H. B. ROBINSON STEAM ELECTRIC PLANT, UNIT NO. 2
APPLICATION OF SELECTION CRITERIA

**APPLICATION OF SELECTION CRITERIA TO THE
H. B. ROBINSON STEAM ELECTRIC PLANT UNIT NO. 2
TECHNICAL SPECIFICATIONS**

CORE PROTECTION BOUNDARIES FOR S-LOOP OPERATION
Figure 2.1-1

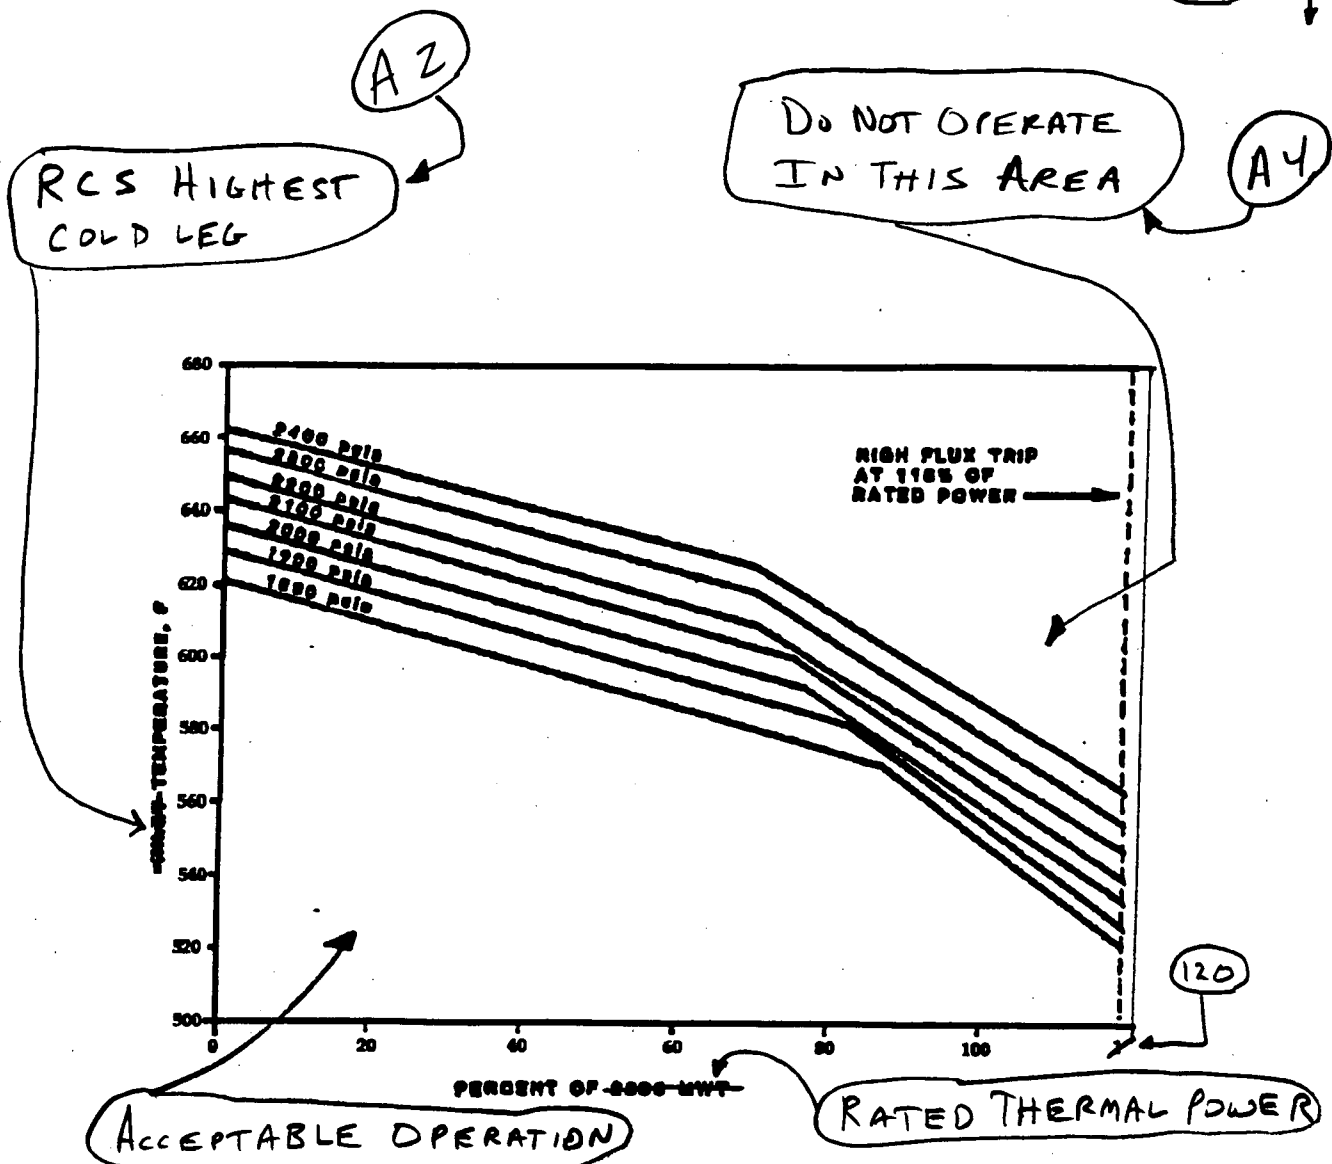
- A2 The CTS 2.1 reactor core SL Specification is not stated in terms of a specific point for the temperature measurement, however the referenced CTS Figure 2.1-1 is specified in terms of inlet (i.e., cold leg) temperature. The ITS specifically describes the SL in terms of the highest RCS cold leg temperature. The addition of the specific reference to "... highest cold leg temperature ..." is an administrative detail added for clarity.

- A3 CTS 2.1.d is not retained in the ITS. CTS 2.1.d provides administrative details defining when the SLs specified in Figure 2.1-1 and in CTS 2.1.b and 2.1.c are exceeded. This type of clarification is included in the comparable ITS Figure 2.1.1-1. See A4 for additional information. The additional administrative detail regarding CTS 2.1.b and 2.1.c merely reiterate that violating the specified limits is exceeding the SLs. This change is consistent with NUREG-1431.

- A4 CTS Figure 2.1-1 does not clearly define the regions of acceptable and unacceptable conditions. Administrative clarifications are included in ITS to delineate the appropriate regions on the figure. This change is consistent with NUREG-1431.

Figure 3.10-2 SHUTDOWN MARGIN VS BORON CONCENTRATION

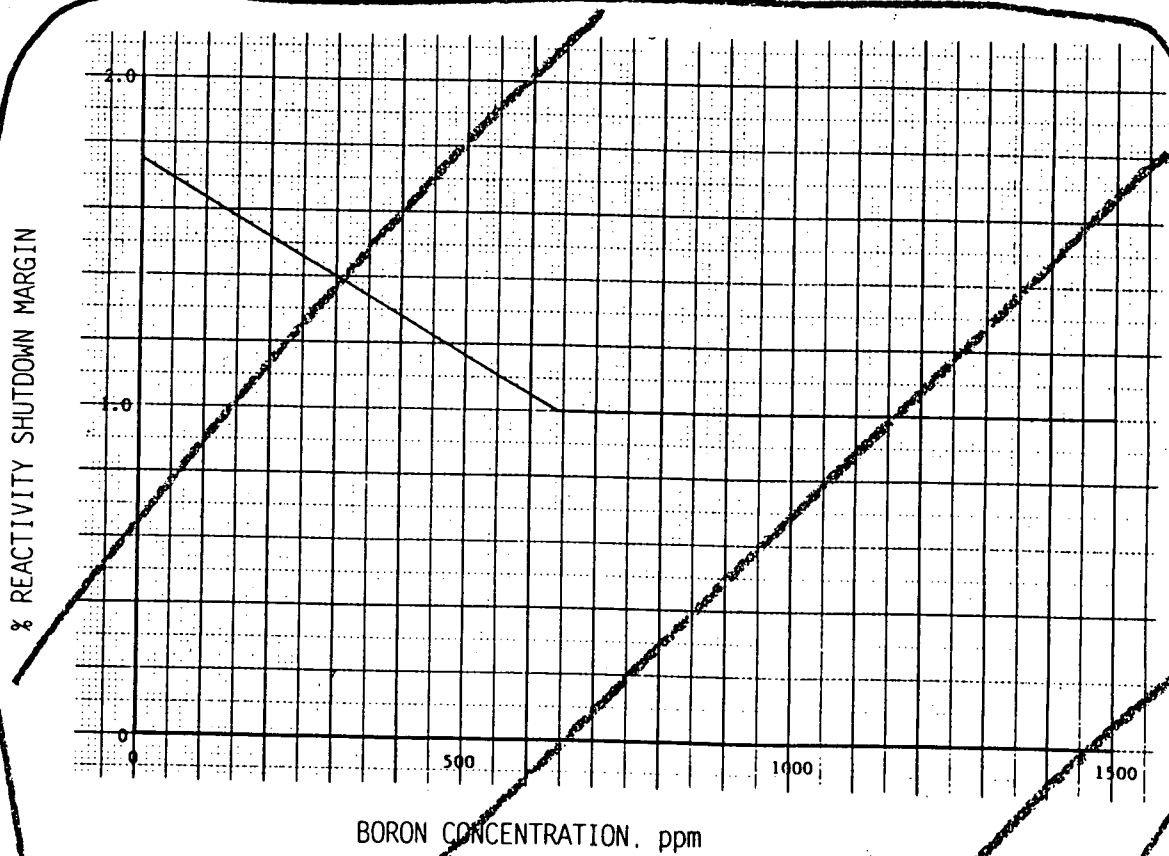
- LA1 CTS Specifications 3.10.8.1, 3.10.8.2, and Figure 3.10-2 provide required shutdown margin values. CTS Specification 3.10.1.4 requires control rod insertion limits be adjusted to the end-of-core values as provided in the COLR at 50 percent of the cycle. These details are not retained in the ITS and are relocated to licensee controlled documents.

Figure 3.1.4-1 (page 1 of 1)
Moderator Temperature Coefficient vs. Power Level

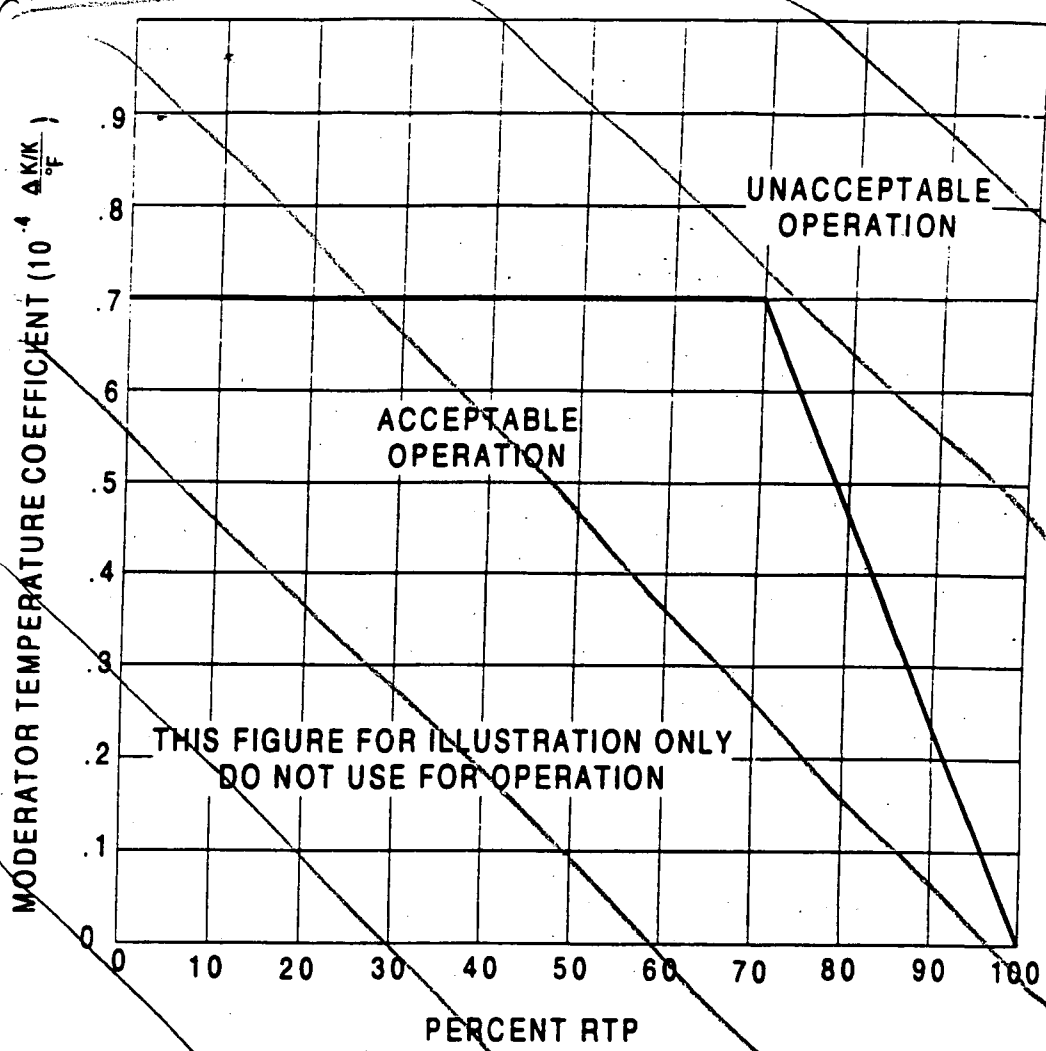
- 3 ISTS Figure 3.1.4-1 is not used in the ITS. The maximum upper limit for MTC consists of two values specified in ITS 3.1.3, obviating any need for the Figure.

Figure B 3.1.6-1 (page 1 of 1)
Control Bank Insertion vs. Percent RTP

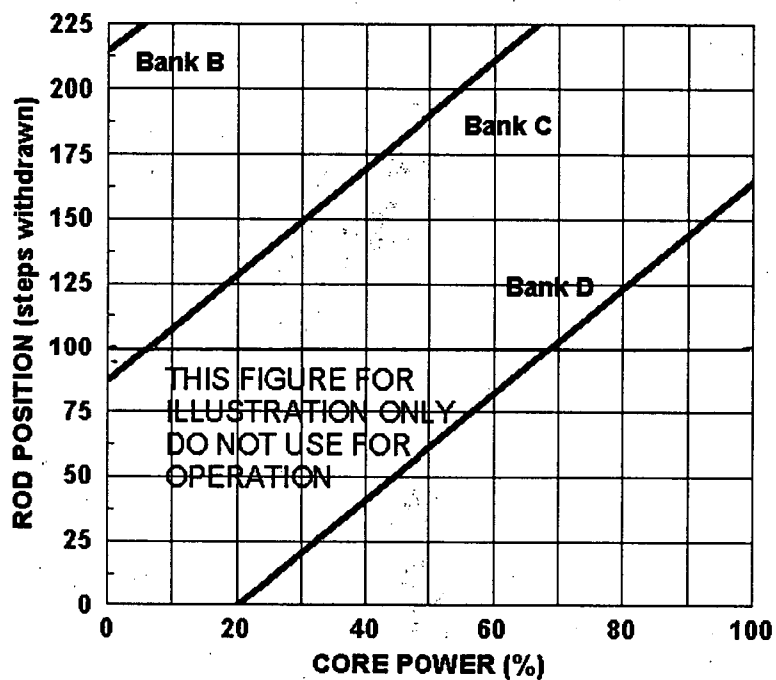
- 33 Plant specific values are inserted in the Bases 3.1.6 discussion. A different example Figure B 3.1.6-1 is inserted to reflect that maximum rod withdrawal is 225 steps, and not 231 steps.
